Subject: Dresden Station Units 2 & 3  
Quad-Cities Station Units 1 & 2  
Proposed Amendment to Facility  
Operating License Nos. DPR-19,  
DPR-25, DPR-29 and DPR-30 Associated  
with Reanalysis of the Loss-of-  
Coolant Accident  
NRC Docket Nos. 50-237/249/254/265

Pursuant to 10 CFR 50.59, Commonwealth Edison proposes to amend the Dresden Station Units 2, 3 and Quad-Cities Station Units 1, 2 Technical Specifications regarding revised Maximum Average Planar Linear Heat Generation Rate (MAPLHGR) limits associated with reanalysis of the Loss-of-Coolant Accident. Reference (a) transmitted the General Electric Report NEDO-24046, dated August 1977, entitled "Loss-of-Coolant Accident Analysis Report for Dresden Units 2, 3 and Quad-Cities Units 1, 2 Nuclear Power Stations (Lead Plant)." NEDO-24046 documents the completion of the ECCS reevaluation and forms the basis for the revised MAPLHGR limits.

FIGURE 3.5.1.B

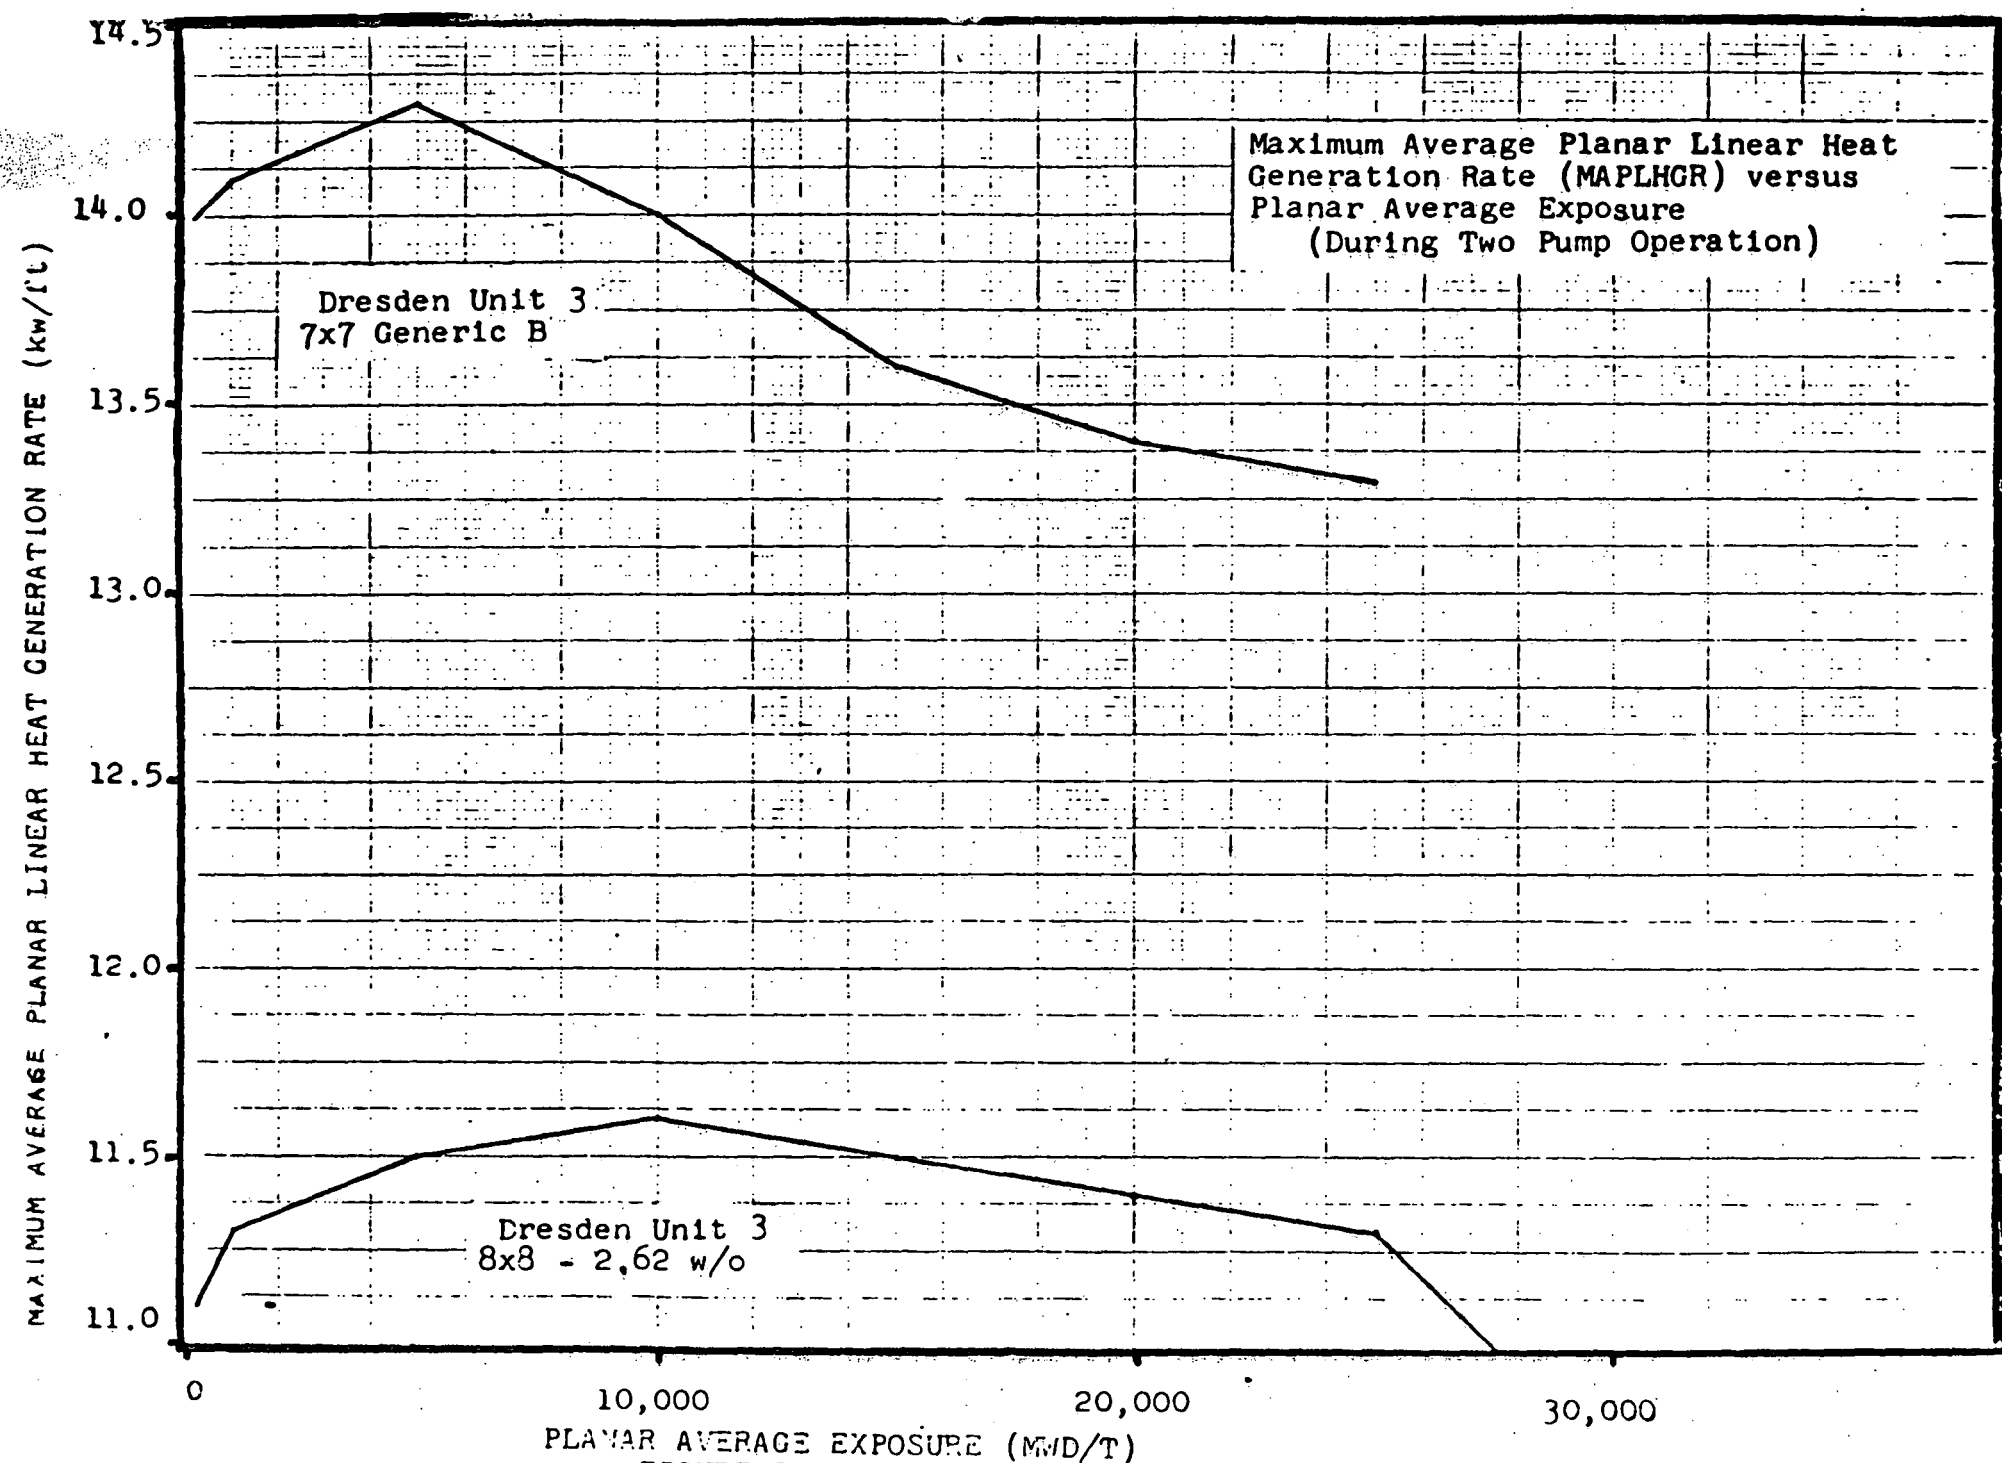
On December 15, 1976, Commonwealth Edison derated Dresden 2, 3 and Quad-Cities 1, 2 limits (MAPLHGR) by 4% to eliminate the double credit for structural absorption. In January 1977, General Electric estimated the net effect of input errors to be a 6.5% decrease in MAPLHGRs. Commonwealth Edison implemented the estimated reduction, on an interim basis, pending a final ECCS reevaluation.

Report NEDO-24046 documents the completion of the required ECCS reevaluation. The analysis was performed using recent NRC approved model changes in the General Electric computer codes. These changes remove unnecessary conservatism and tend to counter the effects of the input errors.

The maximum average planar LHGRs shown in Figure 3.5.1 are based on calculations employing the models described in Reference (1). Power operation with LHGRs at or below those shown in Fig. 3.5.1 assures that the peak cladding temperature following a postulated loss-of-coolant accident will not exceed the 2200°F limit. Those values represent limits for operation to ensure conformance with 10CFR50 and Appendix K only if they are more limiting than other design parameters.

The maximum average planar LHGRs plotted in Fig. 3.5.1 at higher exposures result in a calculated peak clad temperature of less than 2200°F. However the maximum average planar LHGRs are shown on Fig. 3.5.1 as limits because conformance calculations have not been performed to justify operation at LHGRs in excess of those shown.

MAXIMUM AVERAGE PLANAR LINEAR  
HEAT GENERATION RATE (MAPLHGR)  
VS. PLANAR AVERAGE EXPOSURE

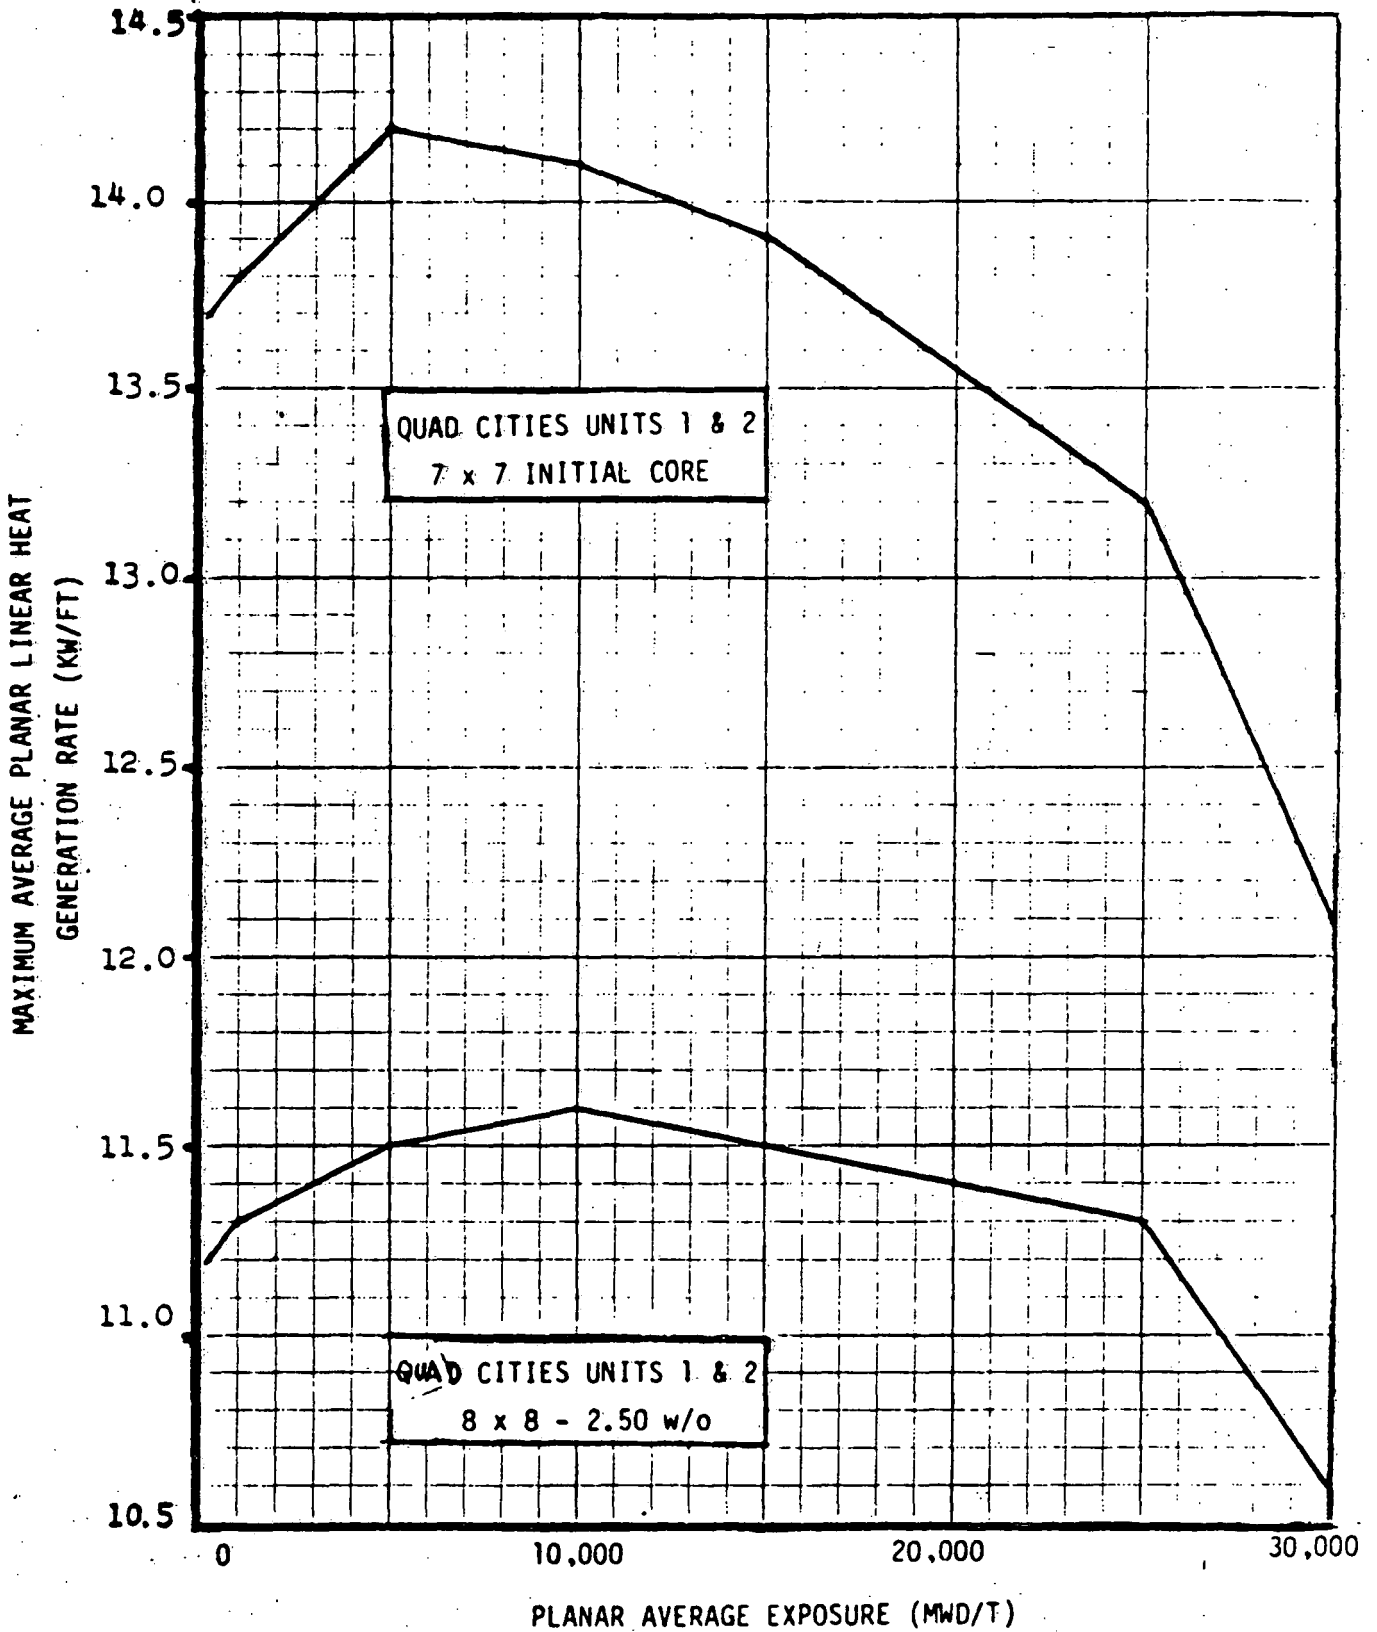
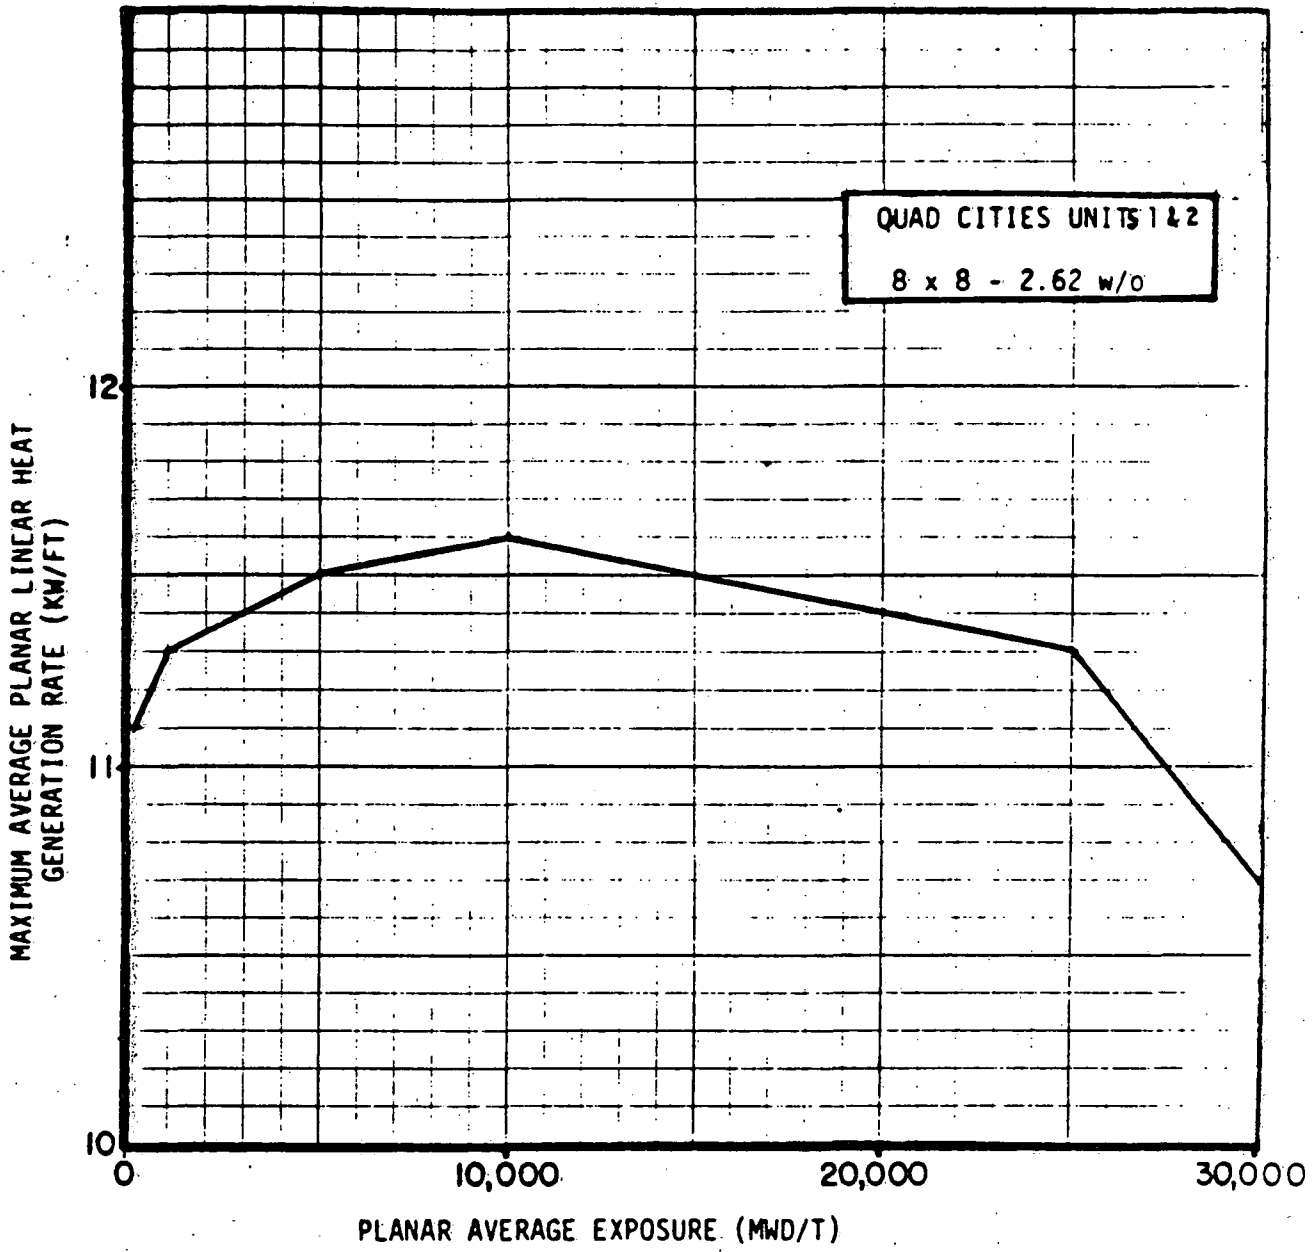
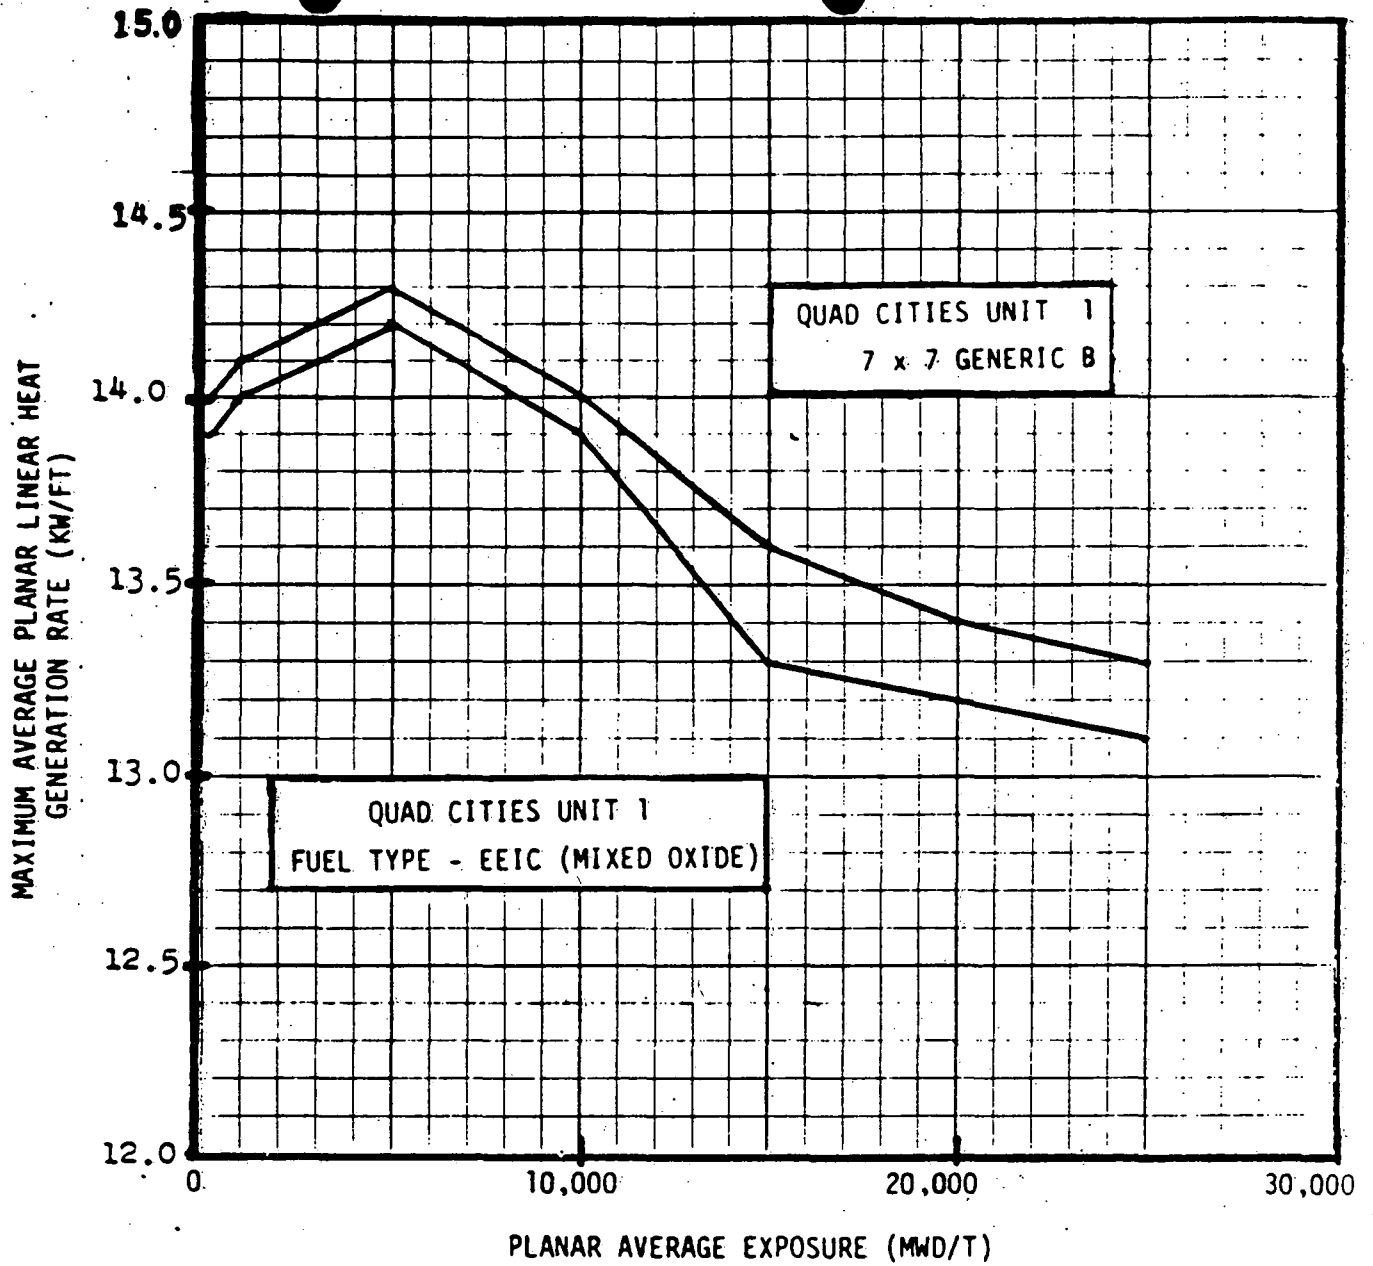
Attachment I contains the proposed changes for Dresden Units 2 & 3 and Attachment II contains the proposed changes for Quad-Cities Units 1 & 2. The referenced NEDO-24046 document and the attached Technical Specification changes have received onsite and offsite review and approval.

The peak cladding temperature following a postulated loss-of-coolant accident is primarily a function of the average heat-generation rate of all the rods of a fuel assembly at any axial location and is only secondarily dependent on the rod-to-rod power distribution within an assembly. Since expected local variations in power distribution within a fuel assembly affect the calculated peak cladding temperature by less than 20°F relative to the peak temperature for a typical fuel design, the limit on the average planar LHGR is sufficient to assure that calculated temperatures are below the limit. The maximum average planar LHGR's shown in Figure 3.5-1 are based on calculations employing the models described in Reference 2.
